O-RING REINSTATED IN HIGH PRESSURE CONTROL VALVE TOPWORKS

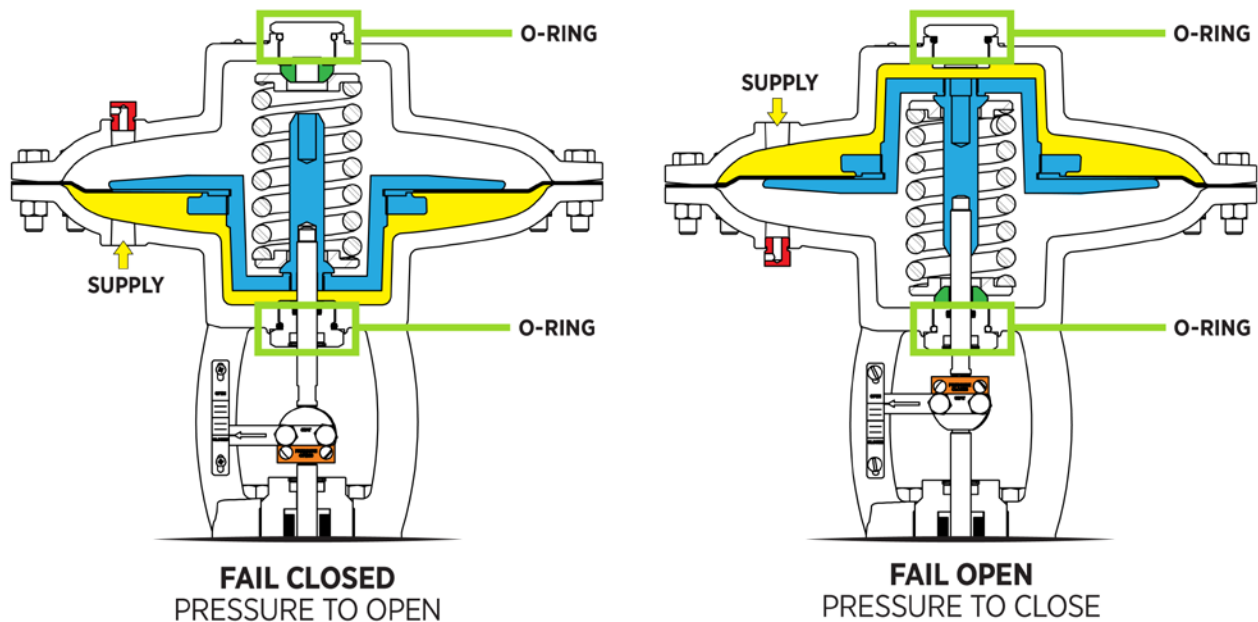
This product notice is to inform you that, based on feedback from customers, we are reinstating the extra O-ring on the atmospheric side of our High Pressure Control Valve Topworks.

This reverses the change announced in our [June 18, 2026 notice](#). Removing the O-ring added complexity and length to the process of converting a topworks from fail closed to fail open, and this reversal restores that O-ring so the conversion process returns to its original steps.

The serial number range for products built without the O-ring on the atmospheric side is 2261590035 – 2262450271.

Effective 9/1/2026, High Pressure Control Valve Topworks again include both O-rings, as they did prior to the June 18 notice. No action is needed on your part.

Associated repair kits will continue to have one less O-ring as communicated in the June 18th notice.
